Missouri Department of Natural Resources
Air Pollution Control Program
2016 Monitoring Network Plan

November 15, 2016

**APPENDIX 6: COMMENTS AND RESPONSES ON PROPOSED 2016 MONITORING
NETWORK PLAN, REVISION 0**

**APPENDIX 7: COMMENTS AND RESPONSES ON PROPOSED 2016 MONITORING
NETWORK PLAN, REVISION 1**

Figure 1. Augusta SO₂ monitors in relation to DNR’s modeled peak concentration areas.

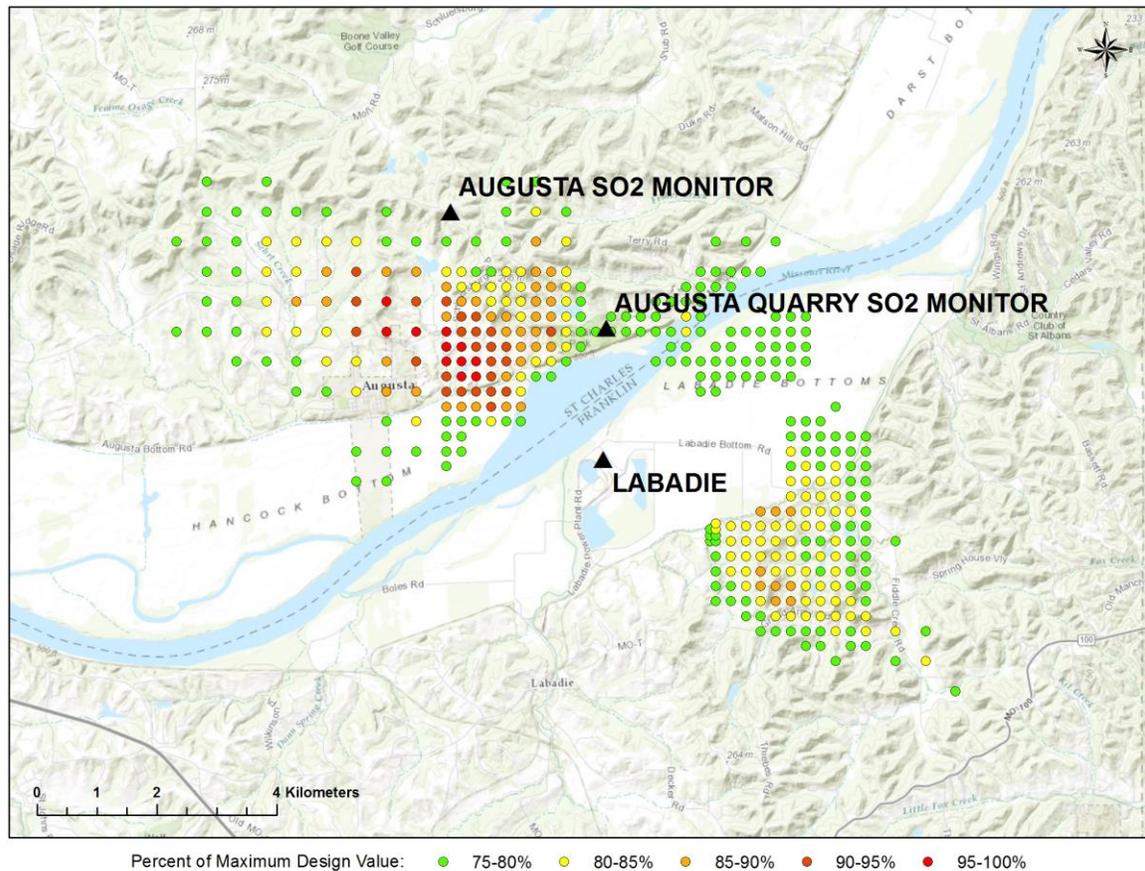
Second, monitoring data from the long-inactive Augusta and Augusta Quarry SO₂ monitors similarly fail to undermine the nonattainment designation required by DNR's modeling. There is no indication that either of those monitors was sited in areas of expected peak concentrations caused by the Labadie plant's emissions. To the contrary, DNR's modeling indicates that they were not sited in areas of expected peak concentrations associated with Labadie's emissions. This is shown in Figure 1, below.

Figure 2. Alternative nonattainment area boundary based on Spirit of St. Louis Airport meteorological data.

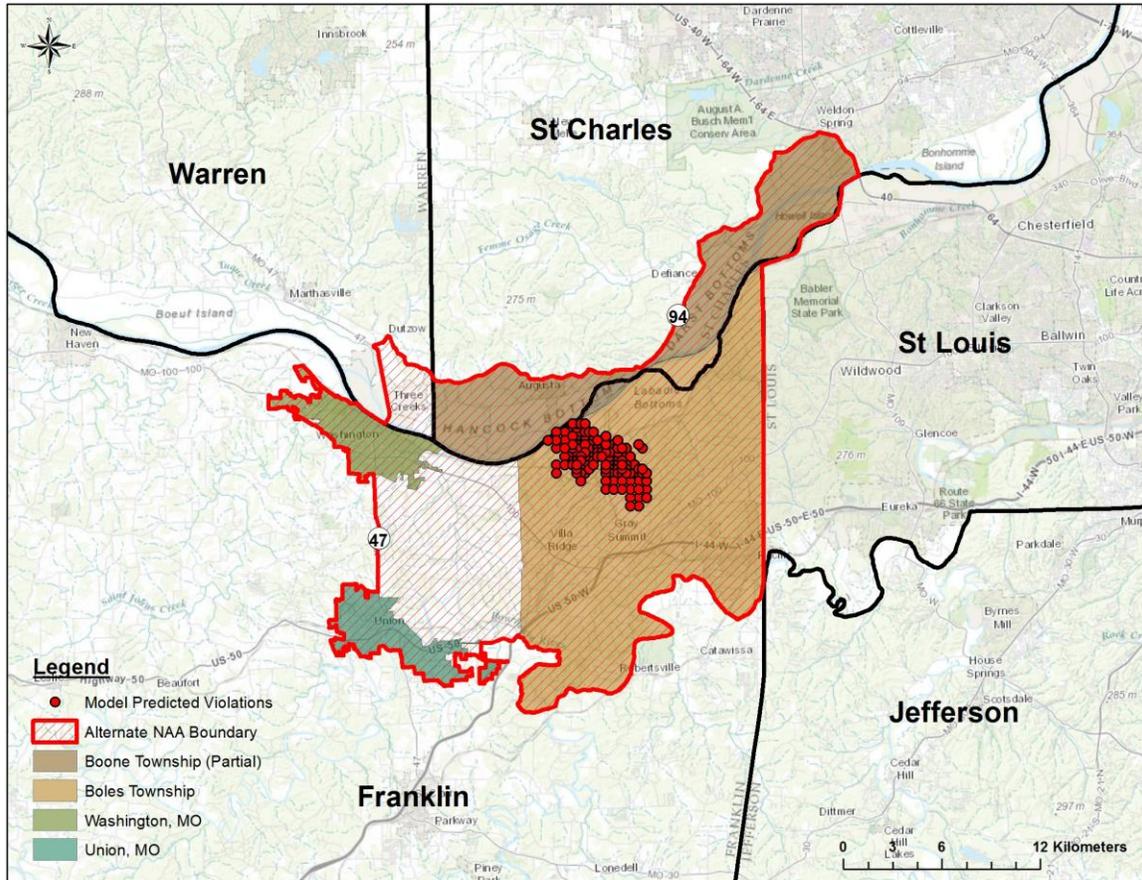
Missouri Highway 94), and the area west of Boles Township bounded by Missouri Route 47 and the municipal boundaries of Washington and Union, Missouri. This is shown in Figure 2, below.

Figure 1. Violating receptors in MDNR’s modeling of Labadie’s emissions using the current version of AERMOD with the beta LOWWIND3 option employed.

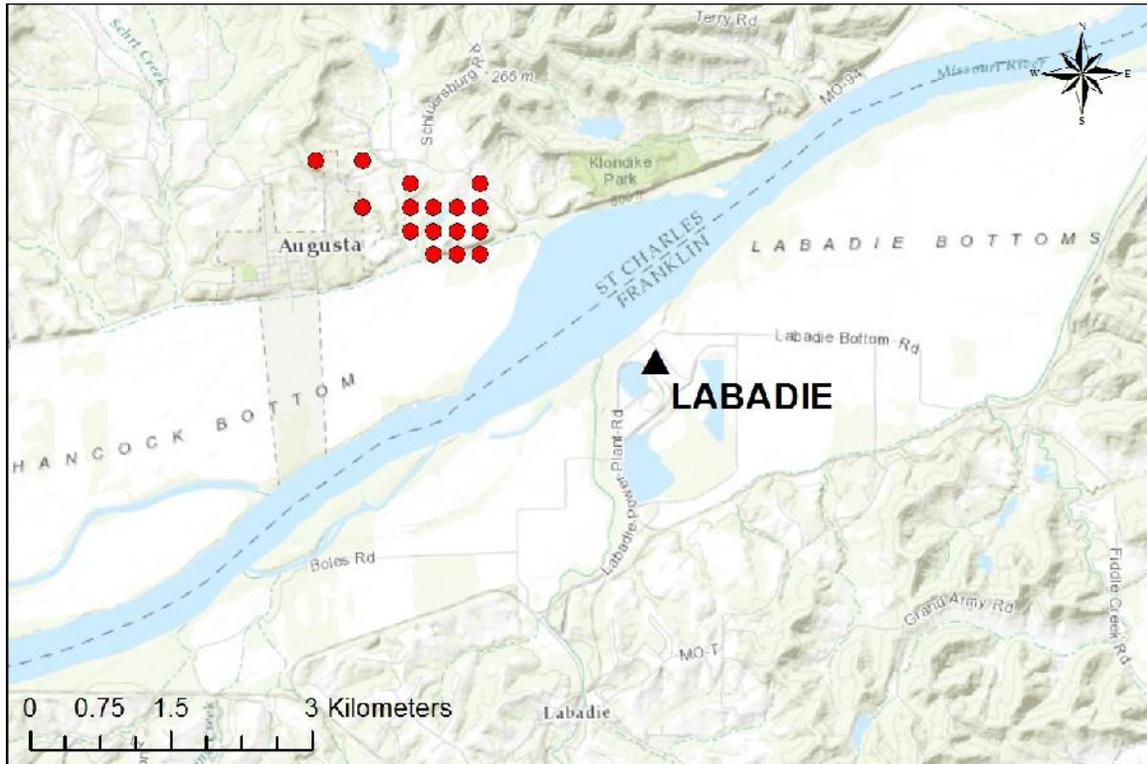
scenario are shown in Figure 1, below.²⁶ Sierra Club’s modeling analysis also shows nonattainment using the current version of AERMOD with LOWWIND3 employed, predicting a peak 99th percentile 1-hour average concentration of 211.9 ug/m³. Violating receptors under this scenario are shown in Figure 2, below.²⁷ This only reinforces EPA’s conclusion that MDNR’s and Sierra Club’s modeling support a nonattainment recommendation.

Figure 3. Violating receptors in Ameren’s beta options modeling of Labadie’s emissions when units 3 and 4 are modeled as separate release points.

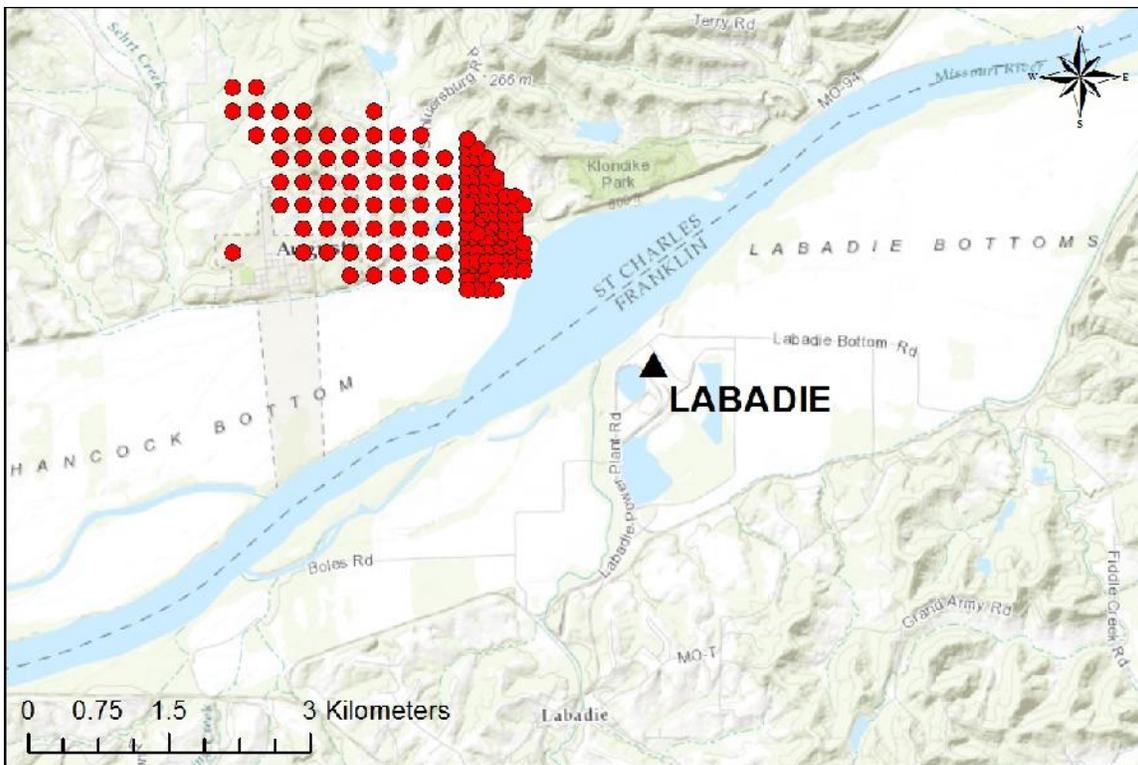
³⁸ Modeling files that show Ameren’s beta options model except that units 3 and 4 are modeled as separate release points are attached hereto as Appendix C, Exhibit 6. Because units 3 and 4 are combined in Ameren’s hourly rate file, we do not have hourly stack temperatures and velocities (based on actual stack flows) for units 3 and 4, nor are we able to back-calculate them. Therefore, we used the hourly stack parameters for the combined stack (“lab34”) for both units to evaluate the effect of modeling them separately. Given that the combined stack parameters were derived by averaging the parameters for units 3 and 4, this should provide a reasonable approximation.

| Modeling Run | Emissions From Units 3 & 4 | Flow Used to Calculate Exit Velocities | Background Monitor Used | Peak 99 th Percentile 1-Hour Concentration (µg/m ³) | Attainment? (Yes/No) |
|--|----------------------------|--|---------------------------|--|----------------------|
| Emissions From Units 3 & 4 Split | Split | Actual | Nilwood, IL | 225.2 | No See Figure 3 |

Figure 4. Violating receptors in Ameren’s beta options modeling of Labadie’s emissions when velocities calculated from standard stack flows are used.

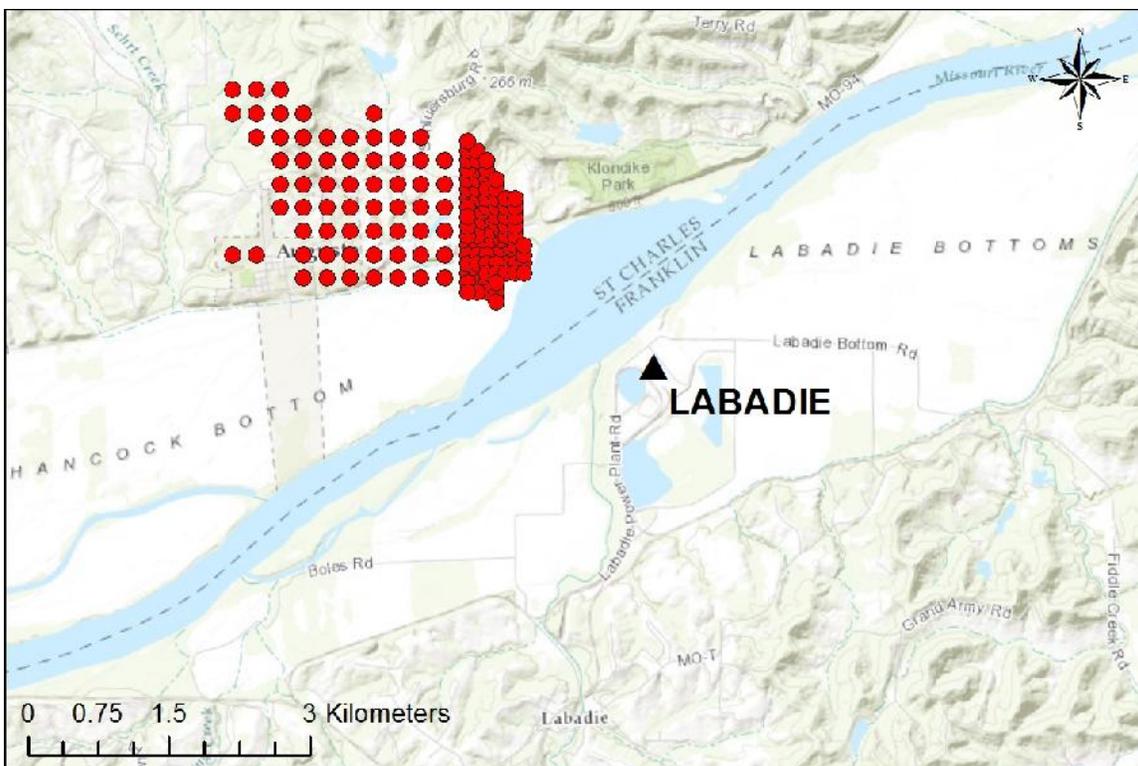
| Modeling Run | Emissions From Units 3 & 4 | Flow Used to Calculate Exit Velocities | Background Monitor Used | Peak 99 th Percentile 1-Hour Concentration (µg/m ³) | Attainment? (Yes/No) |
|--|----------------------------|--|---------------------------|--|----------------------|
| Standard Flow Used to Calculate Velocities | Merged | Standard | Nilwood, IL | 226.4 | No See Figure 4 |

³⁹ Modeling files that show Ameren’s beta options model except that hourly velocities are calculated from standard stack flows are attached hereto as Appendix C, Exhibit 7.

Figure 5. Violating receptors in Ameren’s beta options modeling of Labadie’s emissions when MDNR’s fixed background based on the East St. Louis monitor is used.

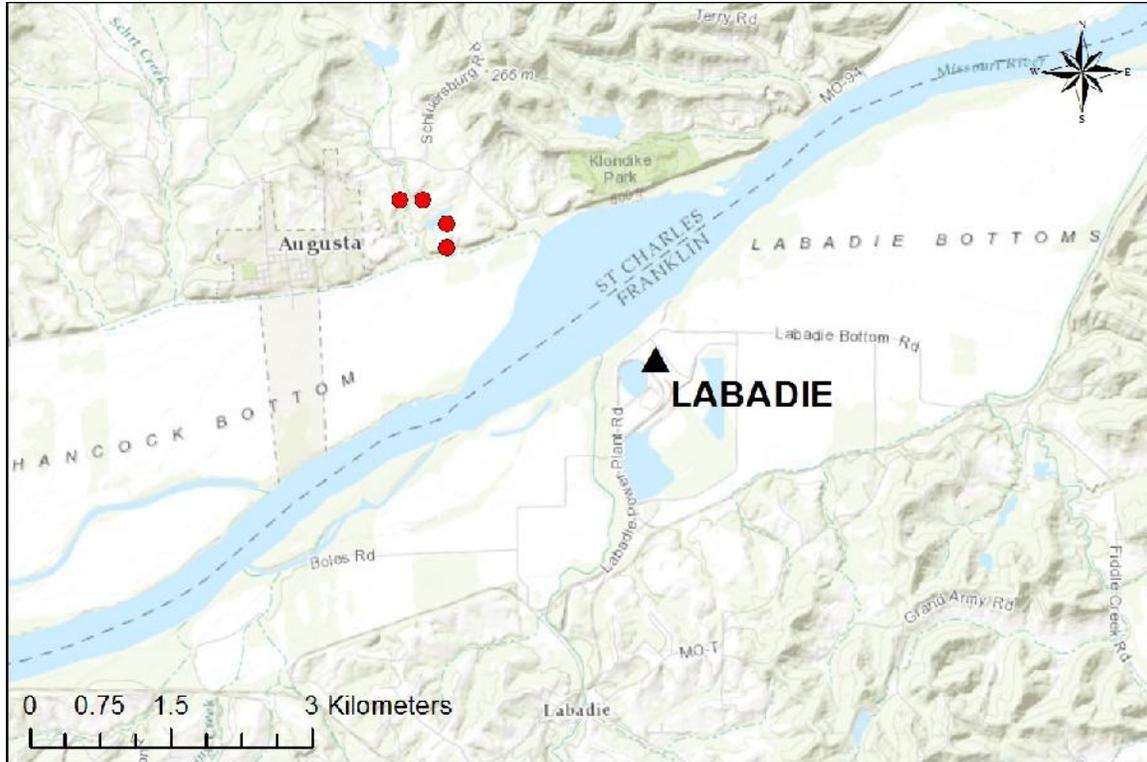
| Modeling Run | Emissions From Units 3 & 4 | Flow Used to Calculate Exit Velocities | Background Monitor Used | Peak 99 th Percentile 1-Hour Concentration (µg/m ³) | Attainment? (Yes/No) |
|--|----------------------------|--|---------------------------|--|----------------------|
| MDNR Background Monitor | Merged | Actual | East St. Louis, IL | 198.0 | No See Figure 5 |

⁴⁰ Modeling files that show Ameren’s beta options model except using MDNR’s background concentrations from the East St. Louis monitor are attached hereto as Appendix C, Exhibit 8.

Figure 6. Wind rose for the historical on-site meteorological tower showing the five highest frequency wind sectors and the percent of hourly winds each sector contains.

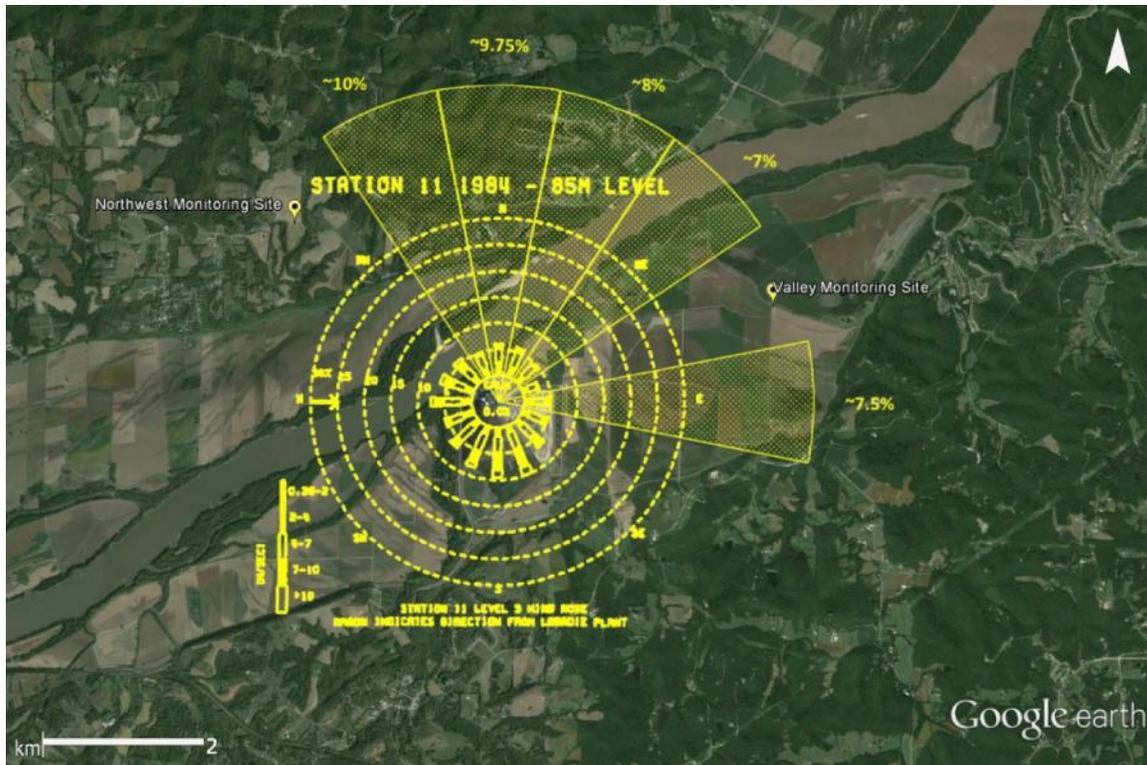
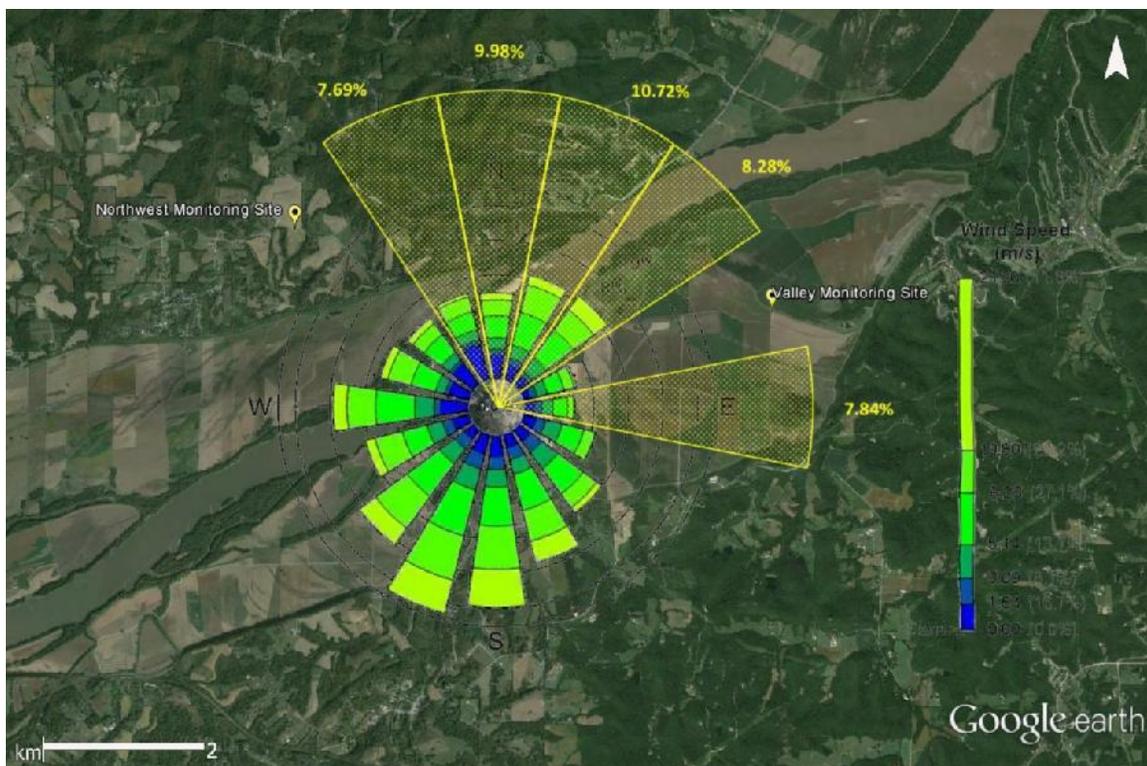
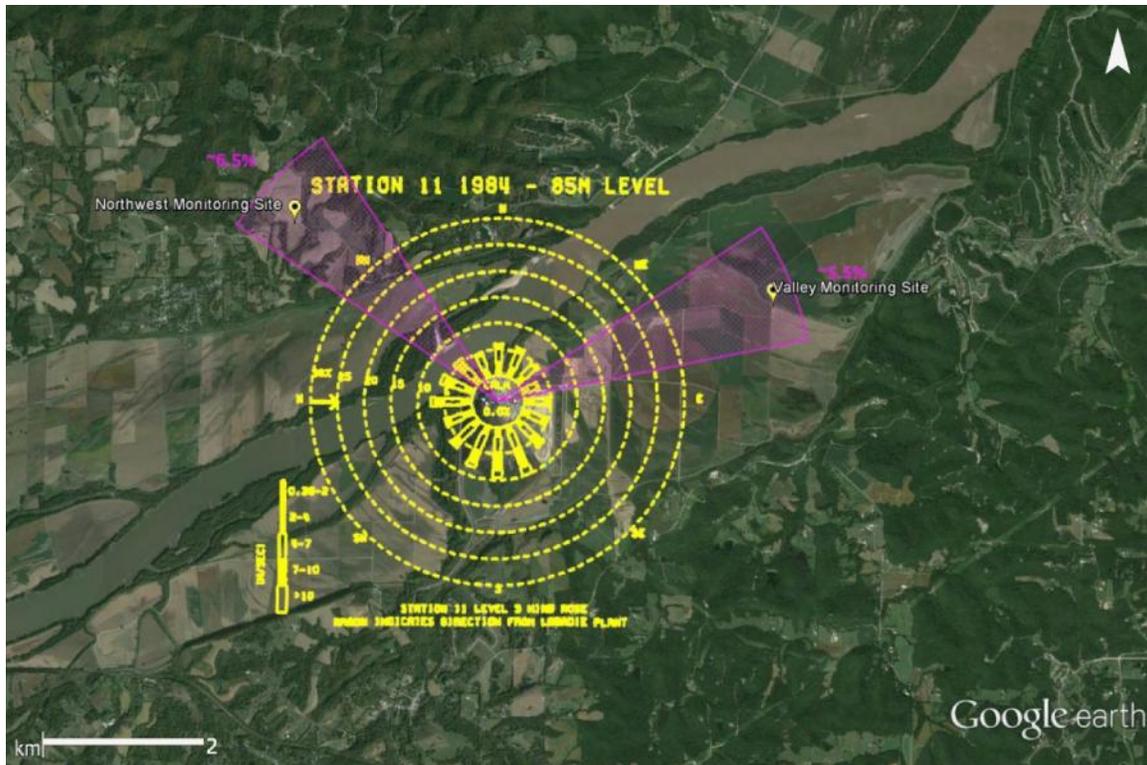
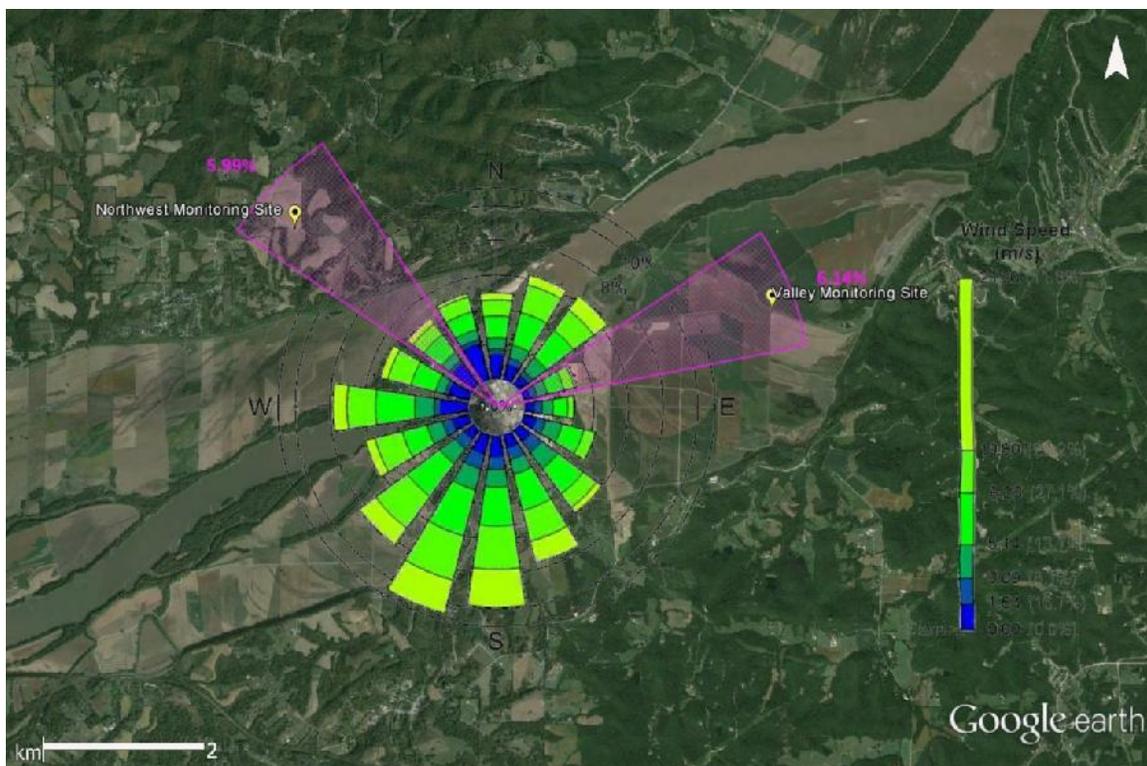
Not so. Wind roses for the historical on-site meteorological tower and the recent WRF modeling show that *the sectors of peak wind frequencies do not include either of the Labadie monitors*, further evidence that the monitors are not located in expected peak SO₂ concentration areas. These wind roses and the five peak wind frequency sectors for each are shown in Figures 6 and 7, below. The peak wind frequency sectors (N, NNE, NE, E, and NNW) collectively contain upwards of 50 percent of all hourly winds but do not include either of the monitors. The same wind roses and the wind frequency sectors that do include the monitors are shown in Figures 8 and 9, below. The two sectors that include the monitors each contain just 6 percent (+/-) of all hourly winds.
